# Groundwater Transfer Review Summary Form

Transfer/PA # T- 13852

Application: T-13852

Applicant Name: G and F Sester Family LLC

### Theis Drawdown Analysis – Authorized From-POA MULT 3476 to Permit G-15183 POA Location

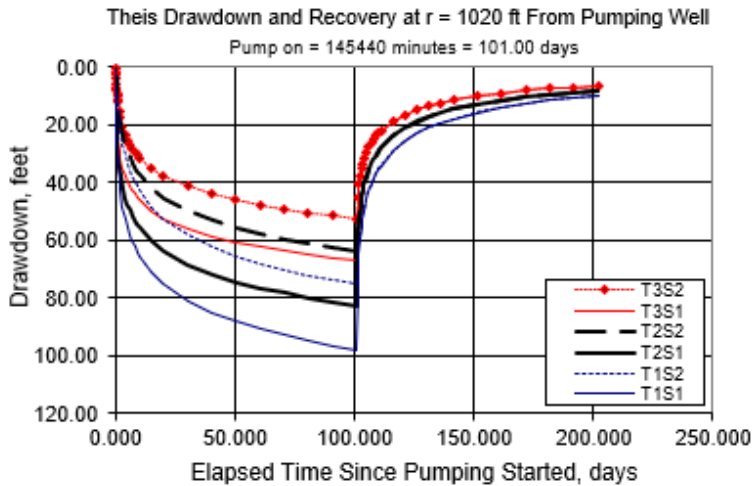
To evaluate the potential additional interference with the nearby POA for permit G-15183, a Theis (1935) drawdown analysis was completed. Aquifer parameters used for the analysis were derived from regional data and studies (Pumping Test Reports; McFarland and Morgan, 1996; Swanson et al., 1993).

To provide a conservative analysis, it was assumed that authorized From-POA MULT 3476 would be pumped non-stop at the maximum authorized rate for the 34.5-acre primary irrigation portion (0.43 cfs, ~193 gpm) up to the associated duty, which would be reached within approximately 101 days of pumping (note: additional pumping rate allocations authorized for MULT 3476 (Well 1) by its other water rights were not included for this analysis. Not stacking those additional authorized rates results in this comparative interference analysis being even more conservative; this is because with less interference drawdown imposed by MULT 3476 on nearby wells, the resulting *net difference* when compared to the proposed change (increased pumping rate at MULT 55482) is effectively greater).

Results of the Theis comparative analysis indicate that interference with the permit G-15183 POA could range from about 36 to 66 feet based on these conservative pumping scenarios. Using pumping water level estimates for the affected G-15183 POA (based on a specific capacity value derived from pumping test data from MULT 3476), and assuming the G-15183 POA well would be completed to 550 ft bls (fully penetrating the Deep Troutdale aquifer), it was determined that sufficient available drawdown would be available in the G-15183 POA well; this is despite the relatively-large amount of additional drawdown (~36-68 feet) predicted under these conservative scenarios. Therefore, it is not likely that the proposed use will result in the G-15183 POA or another similar groundwater right from receiving the water to which it is legally entitled.

### Theis Drawdown Analysis – Proposed To-POA MULT 55482 to Permit G-15183 POA Location

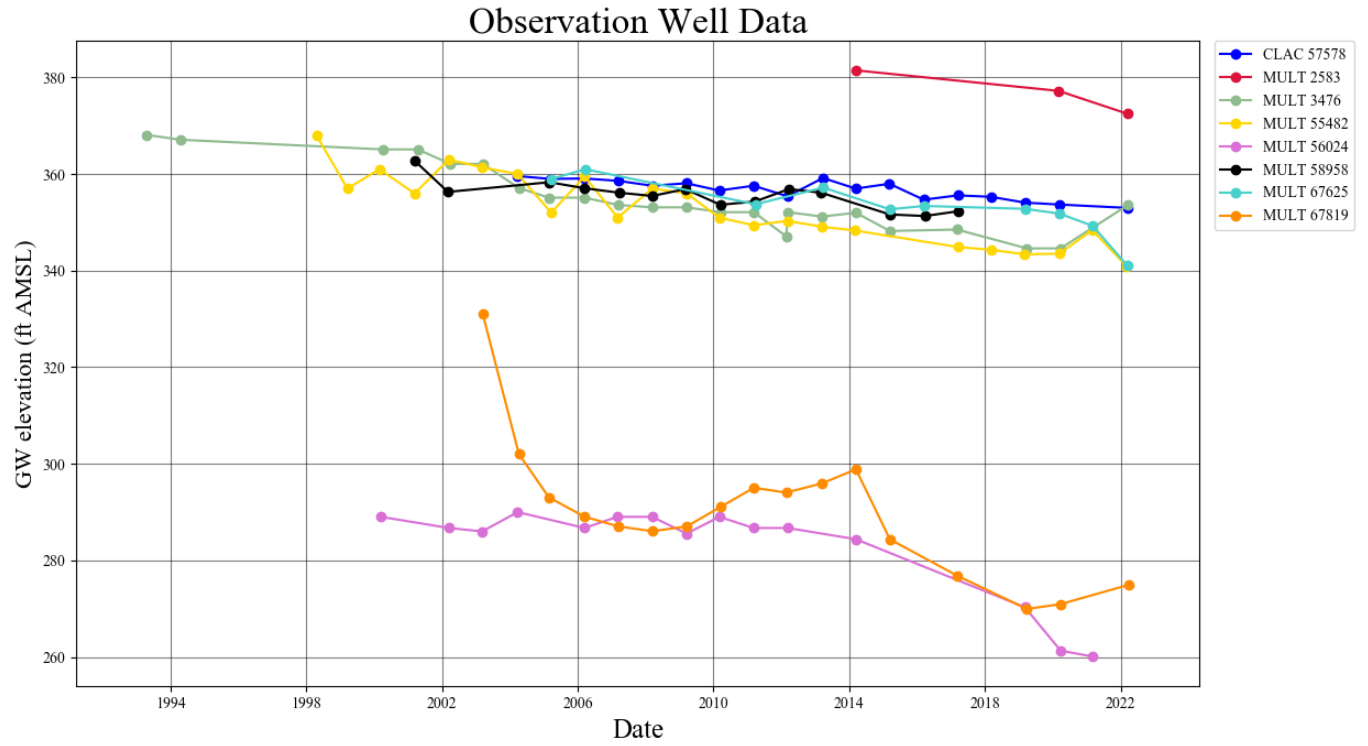
Pumping at the proposed To-POA MULT 55482 location was simulated at 0.93 cfs (~417 gpm), which is the combined total for the rate currently authorized for it by certificate 89728 (0.5 cfs), plus the associated maximum rate authorized by permit G-15758 (0.43 cfs).

**Hydrograph, Authorized From-POA MULT 67819 (Well 3)**

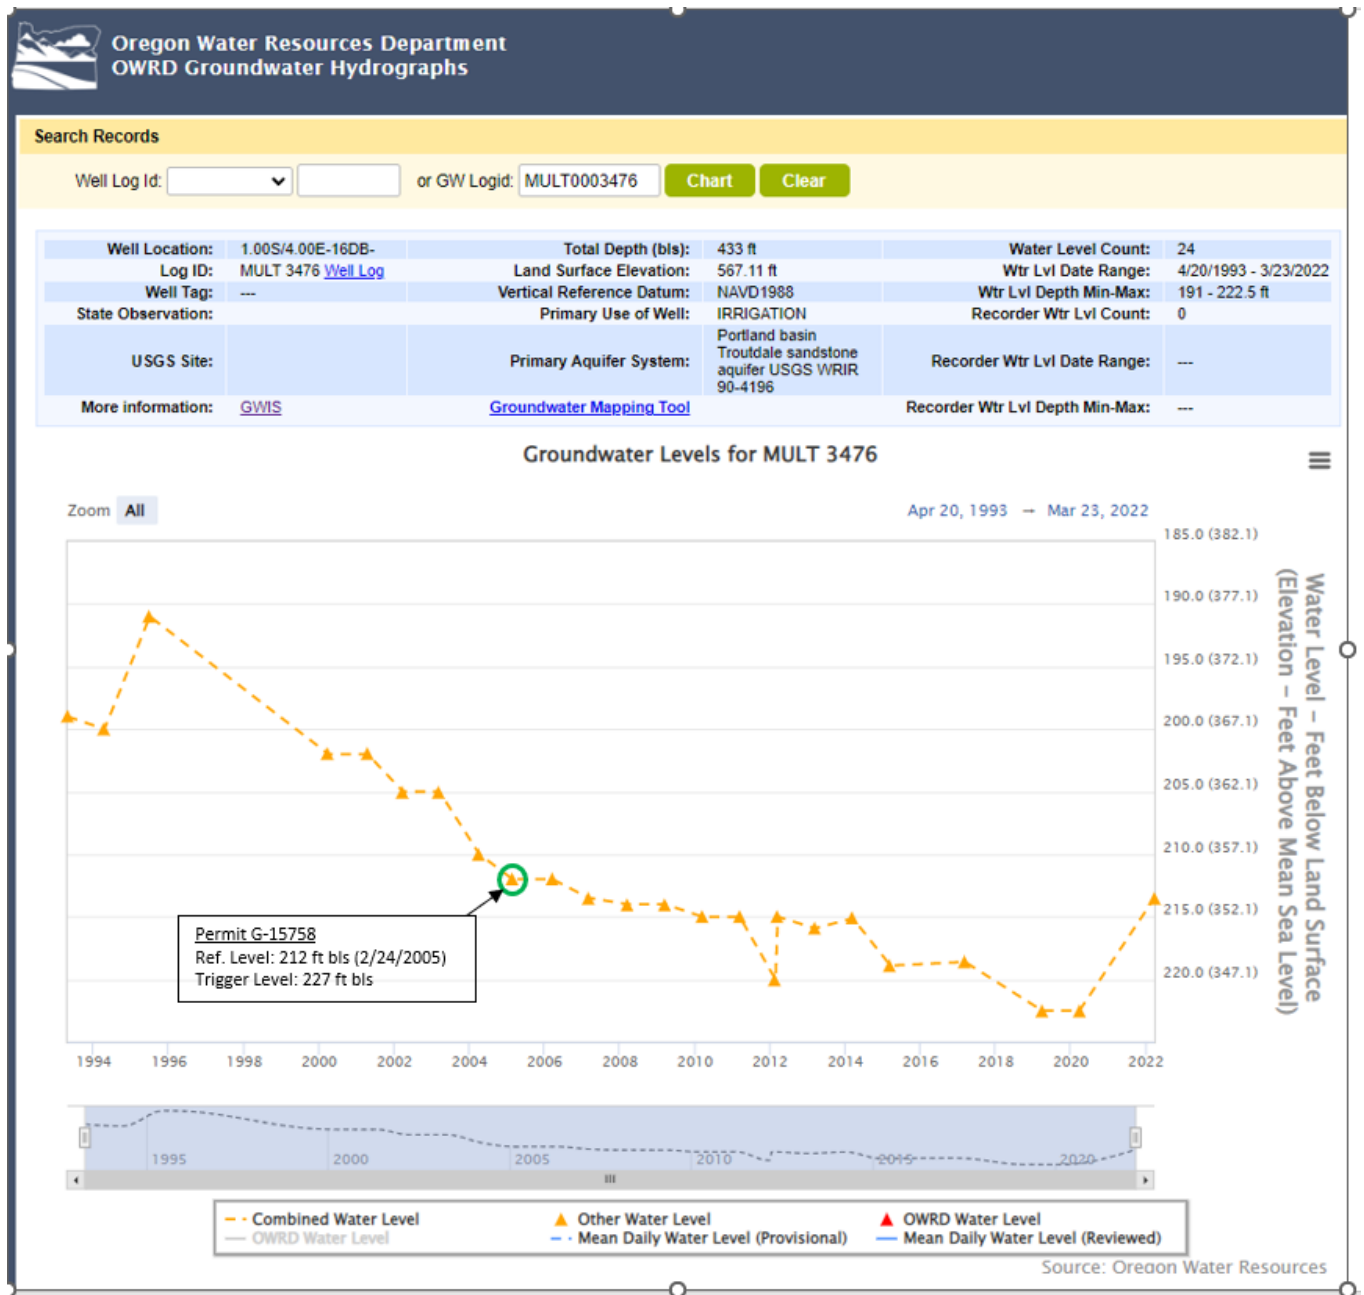
Referring to attached hydrographs, it can be seen that two of these three wells have exceeded their respective trigger levels for this total 15-ft decline condition. From-POA MULT 3476 has not yet triggered this particular decline condition (trigger level: 227 ft bls). However, the other existing From-POA, MULT 67819, triggered this decline condition as of

its March 8, 2017 measurement (trigger level: 341 ft bls); levels through 2022 have remained below this trigger level.

**Given (1) the overall declining groundwater trends in this area and (2) the triggered permit conditions in both authorized and proposed POA, if this proposed transfer is approved, then it is recommended that it contain a provision that allows the proposed use of the To-POA wells only if the specific decline conditions for all of the From-POA wells have not been triggered.** It is understood that a similar provision was included in T-8496 (see related Final Order 59-569 approving T-8496).

**Hydrograph, Proposed To-POA MULT 55482 (Ekstrom Well 1)**

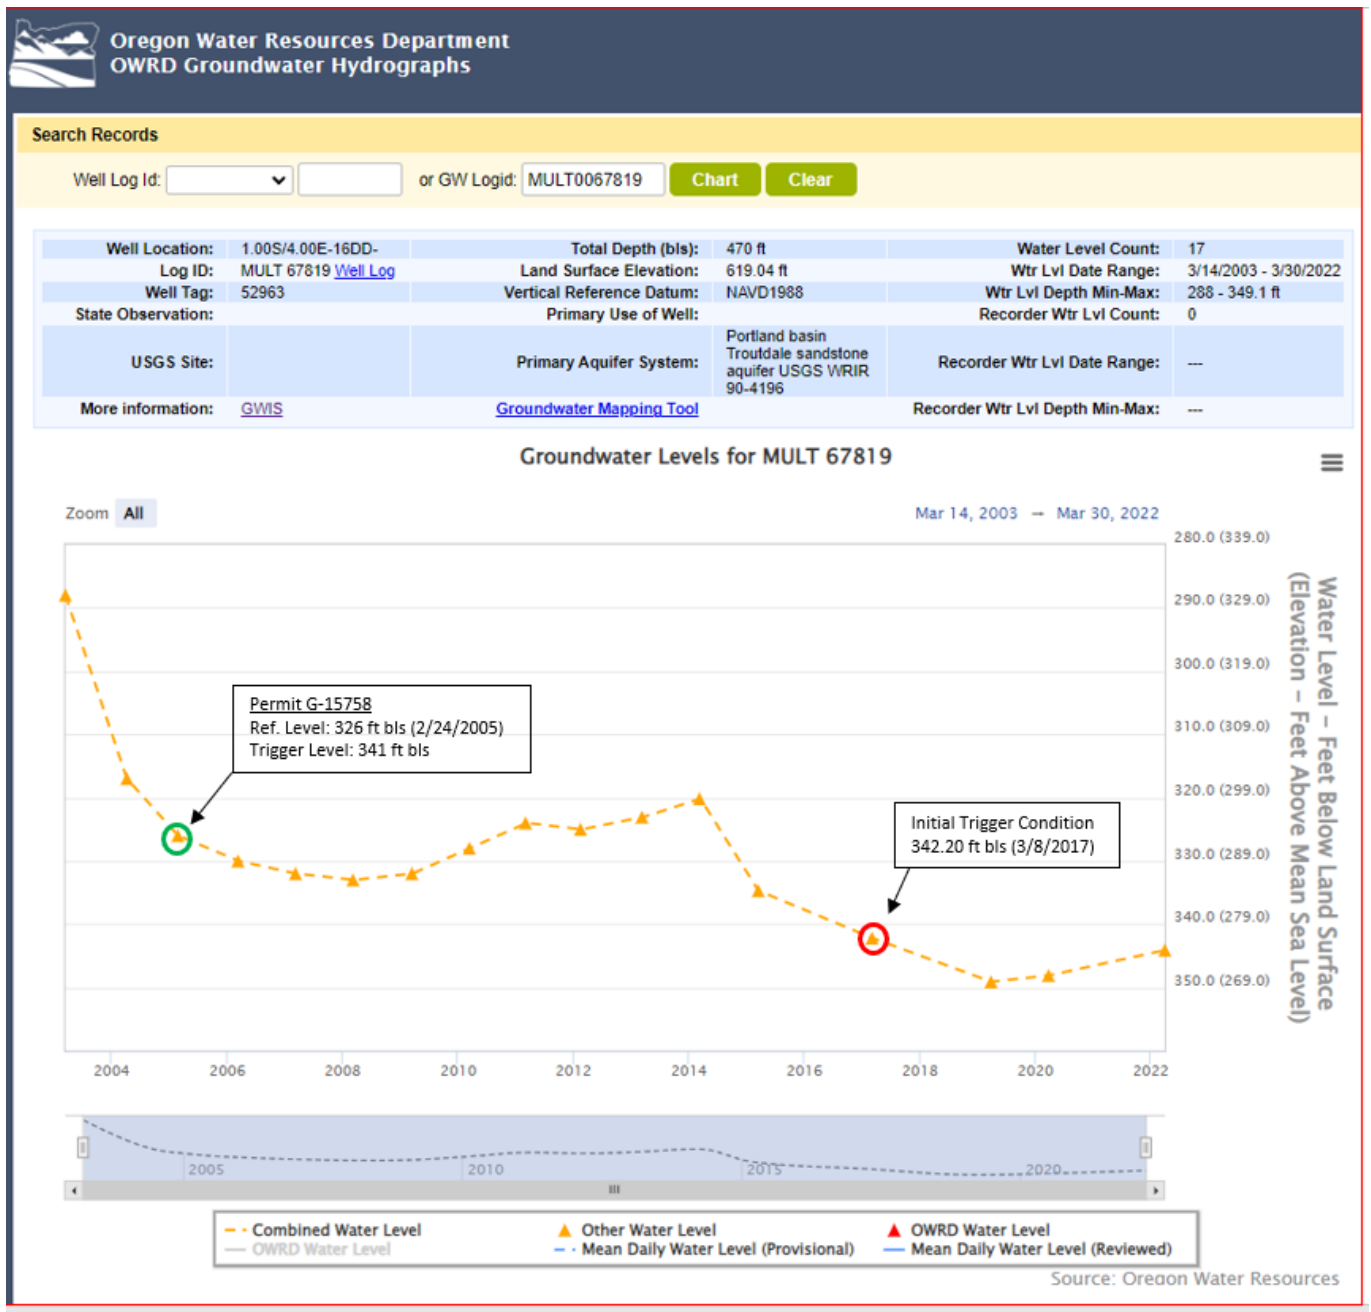
Proposed To-POA MULT 55482 (Ekstrom Well 1) triggered the 15-foot total decline condition as of its March 7, 2022 measurement.

**Because decline conditions have been triggered in both authorized and proposed POA, it appears that this proposed transfer will result in enlargement of permit G-15758.**
